# RECORD OF DECISION
# NIMO Glens Falls - Mohican Street
# Former MGP Site
# Operable Unit No. 1
# MGP Site and Canal

**Glens Falls (C), Warren County, New York**
**Site No. 5-57-016**

March 2003

This responsiveness summary responds to all questions and comments raised during the public comment period. The following are the comments received at the public meeting, with the NYSDEC's responses:

FIGURE 3

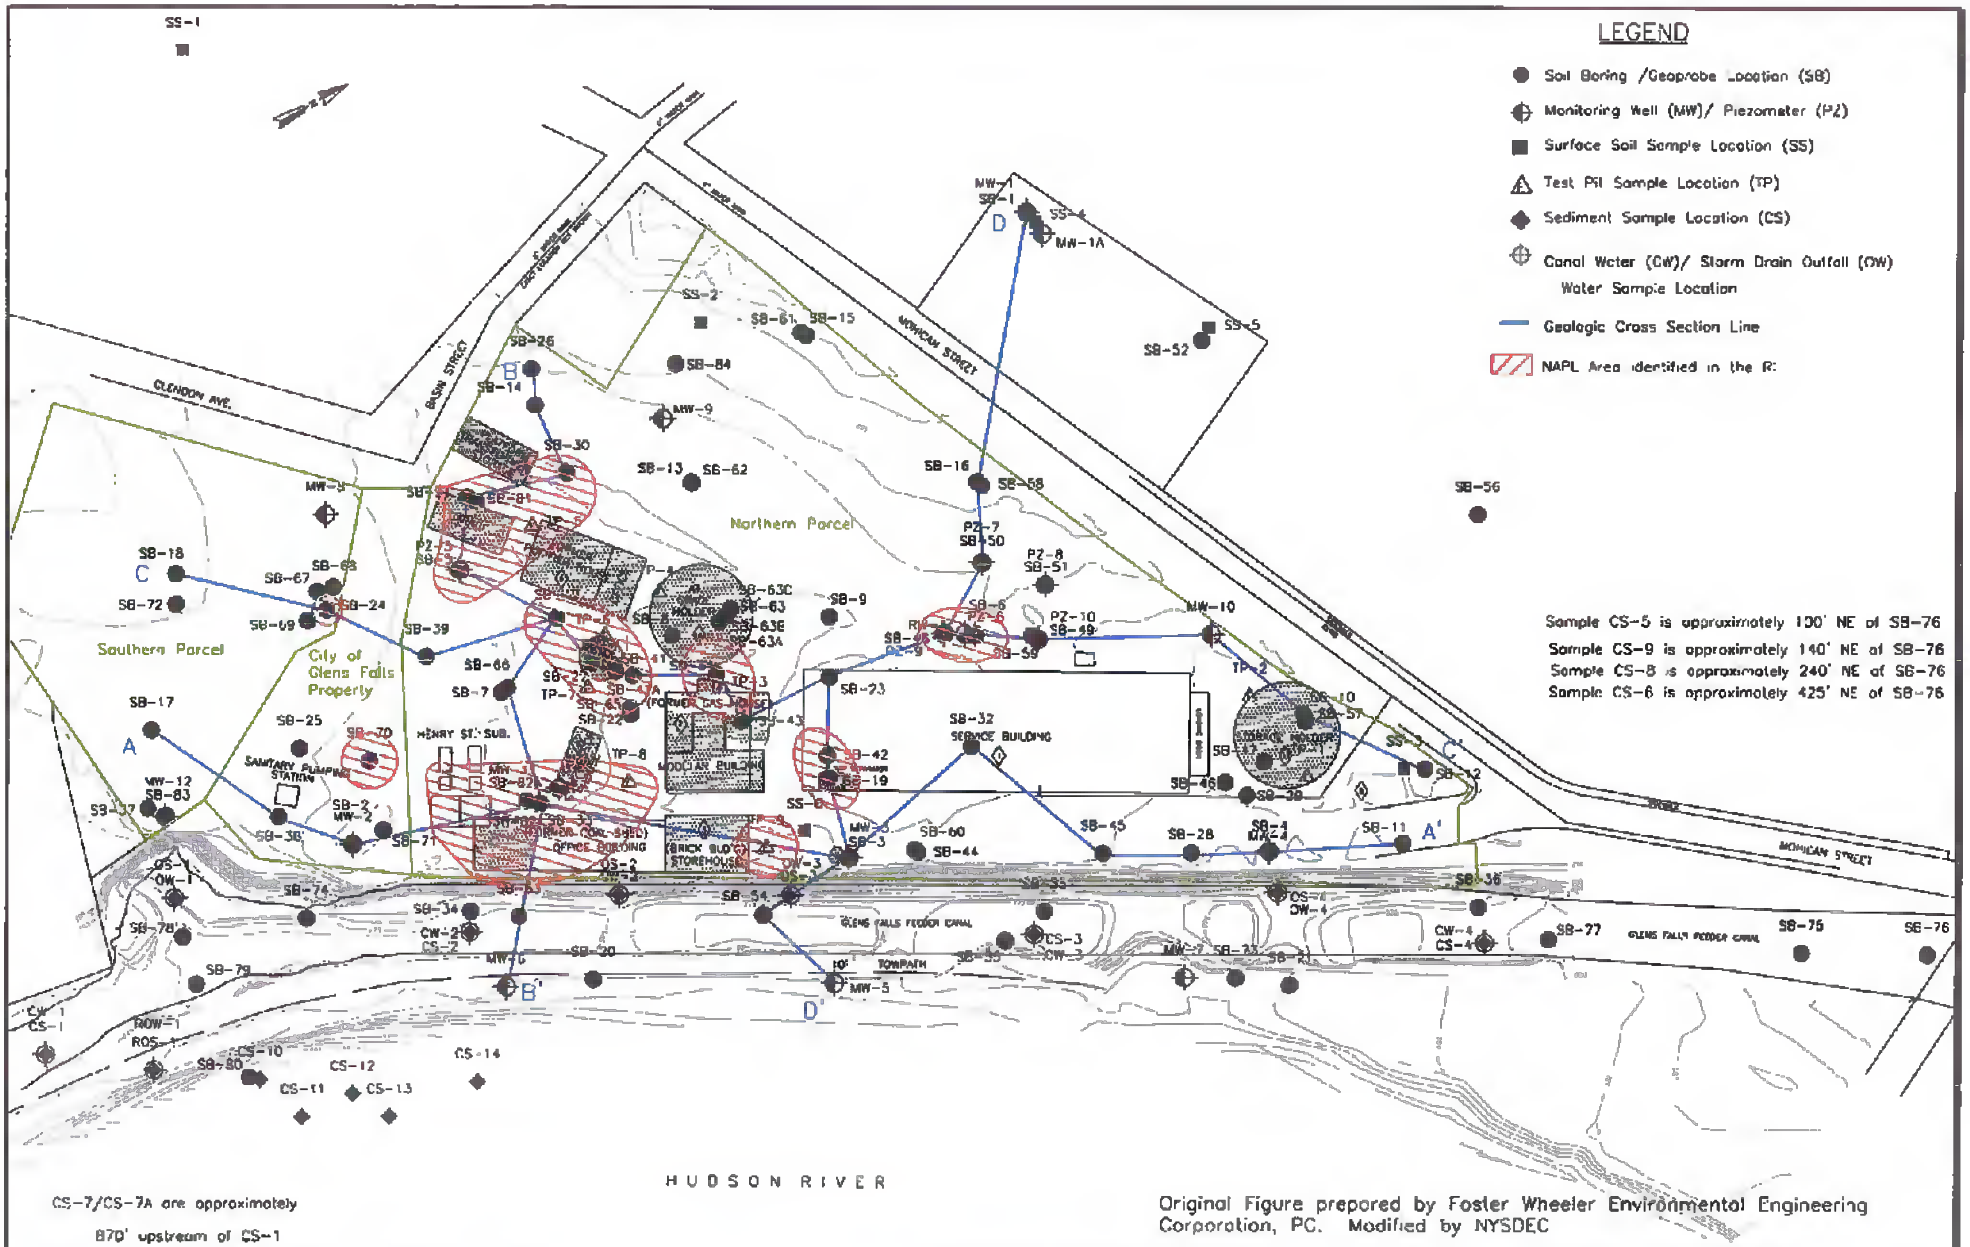
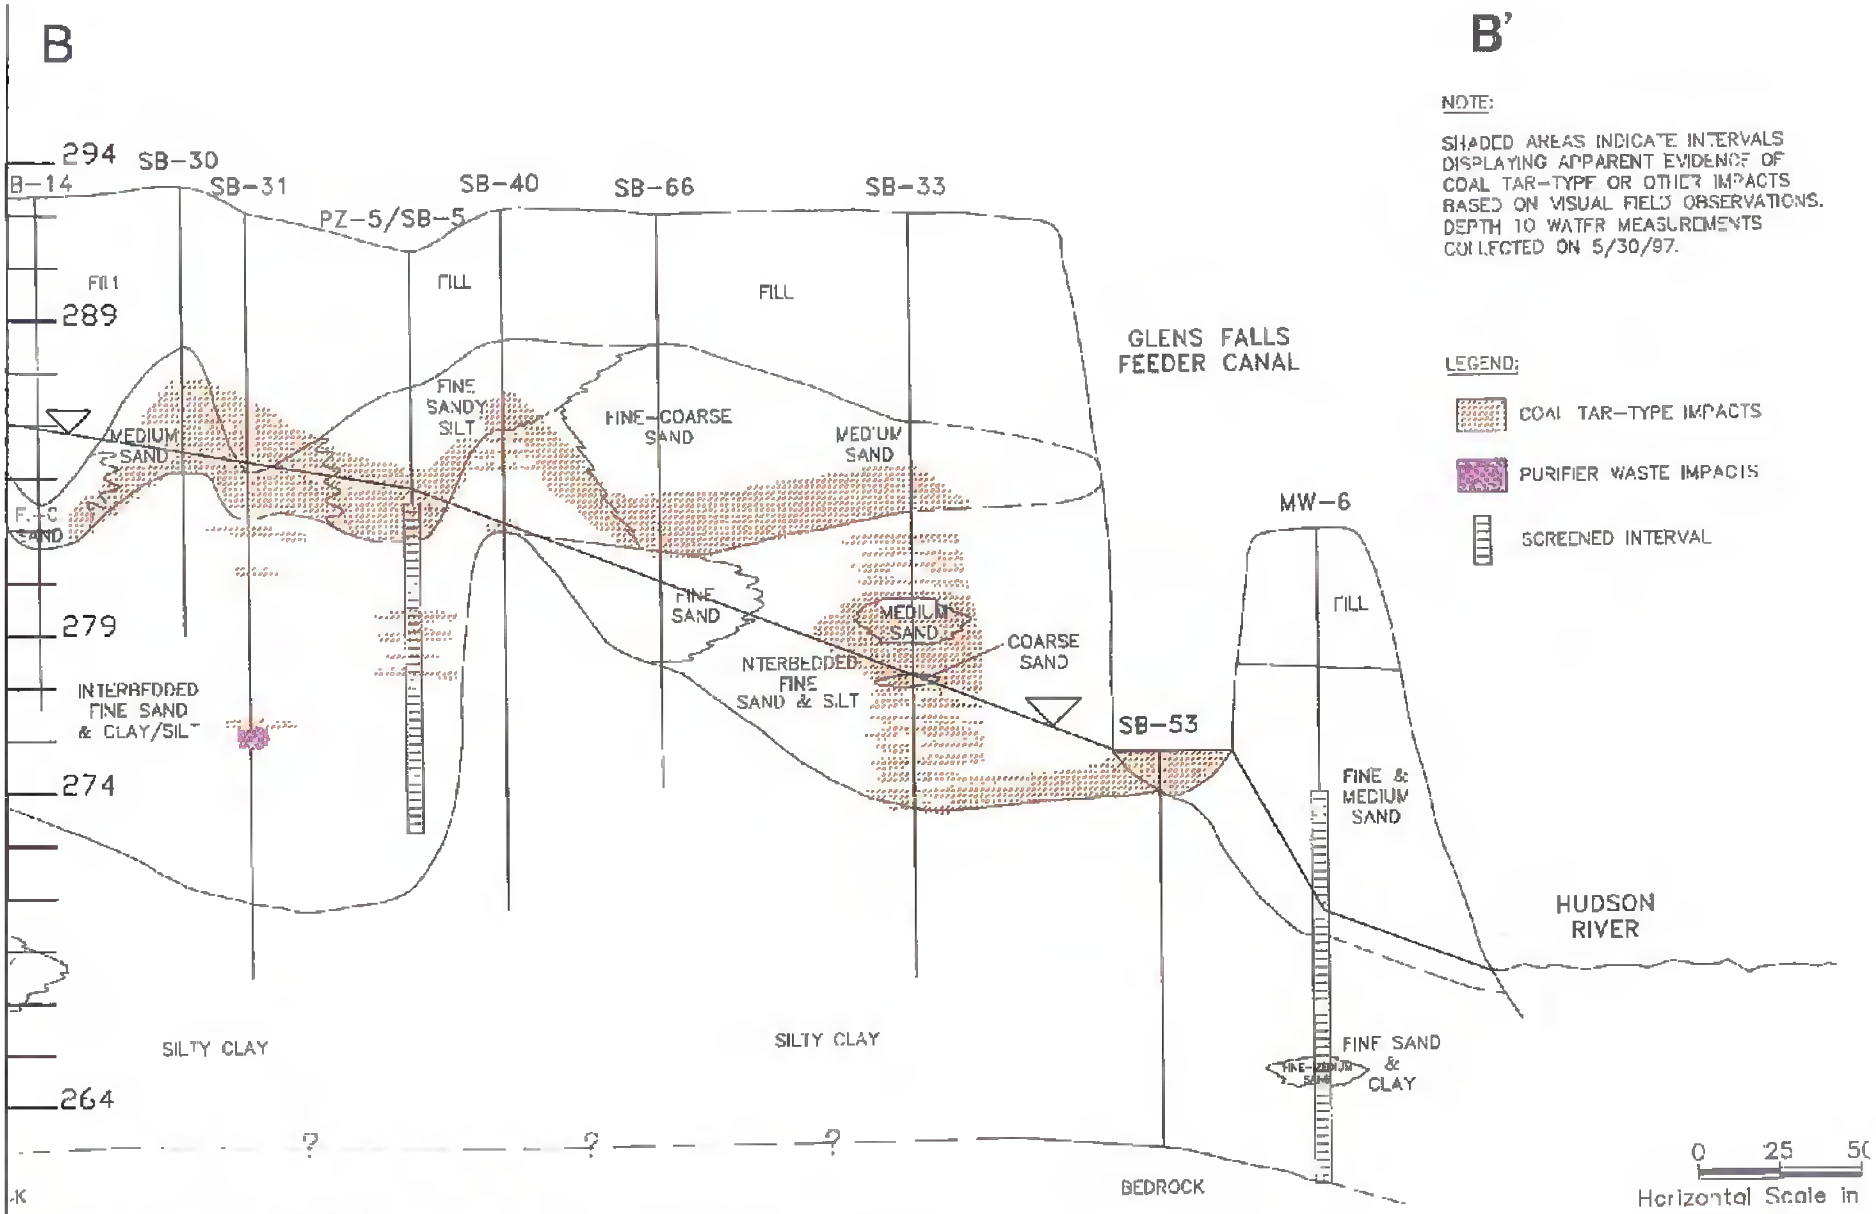
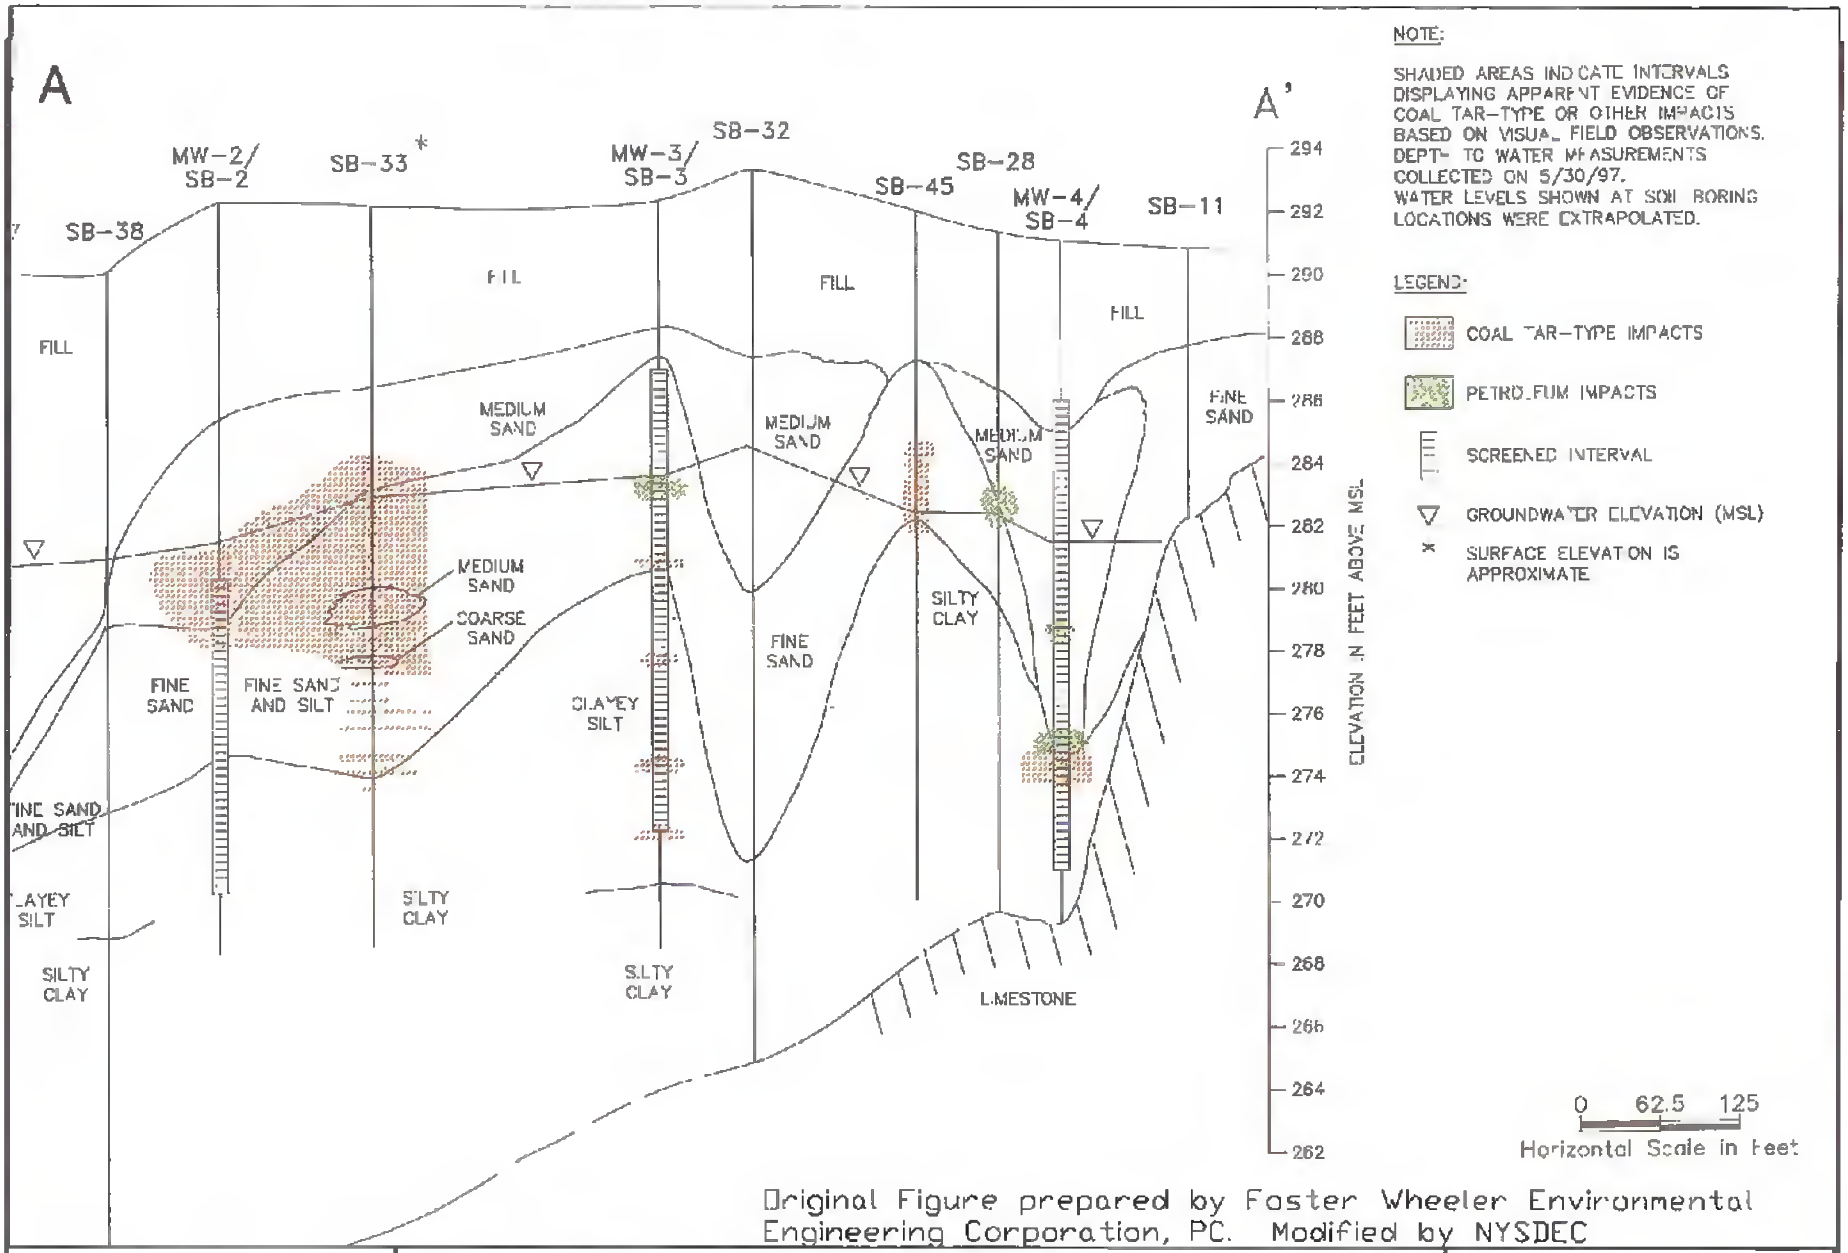
**Comment 60:** Page 9, 2nd column, last full paragraph, This paragraph should be revised to note that the cross sections depict BTEX and PAH impacts, not Source Areas so that the sentence now reads, "Please refer to Figures 3, 4, and 5 for cross sections that illustrates subsurface conditions at the site, and the identified subsurface BTEX and PAH impacts in relation to the former MGP structures."

**Response 60:** The sentence has been revised. The sentence now reads, "Please refer to Figures 3, 4, and 5 for cross sections from the SRI Report that illustrate the subsurface conditions at the site, and subsurface BTEX and PAH contamination in relation to the former MGP structures. Please refer to Figure 7 for the areas identified as, "source areas."

FIGURE 7

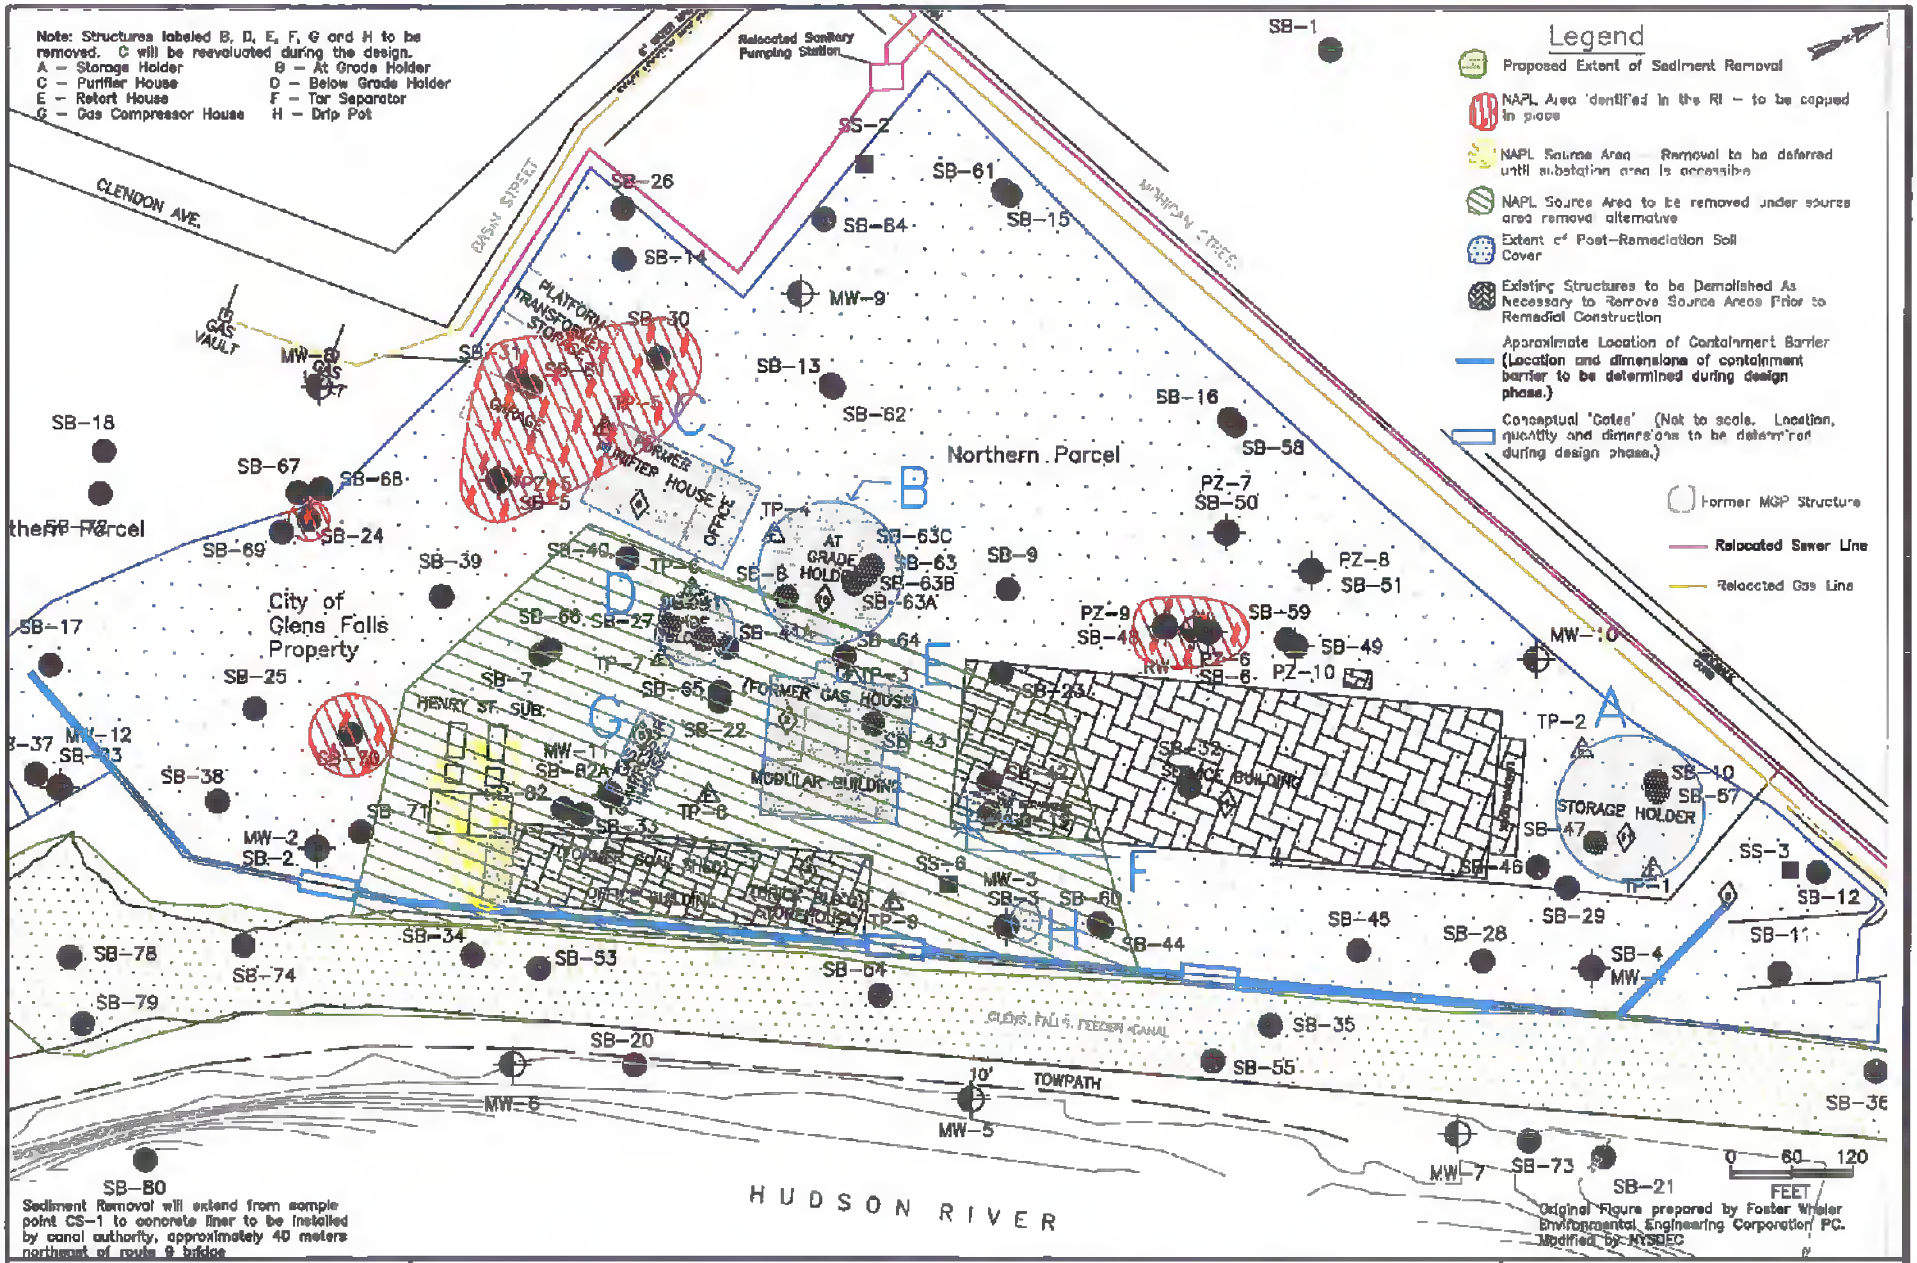
**Comment 20:** The Record of Decision should also reiterate that MGP structures containing significant volumes of soil saturated with NAPL within the polygon are the focus of the removal, as noted on Figure 7. As previously discussed with the Department, the feasibility and need to remove these structures should be evaluated during the predesign phase.

**Comment 21:** The FS indicates that any uncertainties identified during the RI/FS would be resolved through the predesign investigations, which will include the further delineation of NAPL impacts within the polygon identified for removal in Figure 7, the former MGP structure labeled C (former purifier house), and the former MGP structure labeled B (at grade holder) in Figure 7. The Department needs to ensure that the ROD incorporates this concept.

**Comment 29:** A general comment on Figure 7 relative to the "Service Building". NM would prefer to evaluate the need to keep the Service Building during the pre design activities. NM believes that the Tar Sump can be addressed without removal of the building.

**Comment 32:** The Record of Decision should clarify that the "Source Areas" subject to potential soil removal are limited to the polygon area on Figure 7 of the PRAP which contains structures D, E, F, G and H per the FS. A schematic representation of the preferred site wide alternative was presented in Figure 6-1 of the Final FS Report. This alternative encompasses locations where NAPL has not been identified in soil borings advanced at the site. Therefore, as agreed upon between NM and NYSDEC at our October 10, 2002, meeting the polygon conceptual extent of removal has been acknowledged by all parties as representing a worst-case NAPL source area removal scenario. Accordingly, the lateral extent of the predesign

**Comment 37:** Figure 7 should clearly indicate what structures are associated with each letter.

**Comment 70:** Cross hatching in Figure 7 for areas of potential removal must be revised to be consistent with the legend.

**Response 20:** The need for and feasibility of this work was clearly documented and established by the RI/FS. In agreement with these reports, the Department has concluded and defined in the Record of Decision their removal, as well as the disposal/treatment of the contaminants within and adjacent to these structures.

**Response 21:** The Department accepted this language in the FS, as Niagara Mohawk maintains there is some uncertainty associated with the extent of contamination in the two identified structures. Based on the presence of substantial contamination outside of three of the four walls of the former structure C, experience at numerous other sites where purifier structures contain significant tar and the results of test pit 5, the Department is confident that contamination within this structure would warrant removal. However, the Department also acknowledges that there are no borings within this structure and the resulting uncertainty is best resolved in the remedial design. Again based on experience at other MGP sites, the results of test pit 4, and the results of soil borings SB-8, SB-63A, SB-63B and SB-63C, the Department maintains that structure B is clearly a source area and will require the removal of this structure, as well as the disposal/treatment of the contaminants within and adjacent to this structure. Hence the language that was utilized in the Record of Decision. The FS, the PRAP and now the ROD, were developed with the understanding that excavation within the referenced polygon may identify subsurface conditions that will cause the excavation and disposal/treatment volumes to be either increased or decreased, within the limits of the polygon.

**R sponse 29:** While the NM FS called for the demolition of the service building, which is the basis for this statement in the PRAP, the Department is open to reconsideration of the need, provided the agreed upon source area materials can be removed from the site. The crew facility will need to be demolished to install the barrier\treatment wall and remove source areas, as identified by the NM FS. The ROD has been modified accordingly.

**Response 37:** Figure 7 has been revised to address this item.
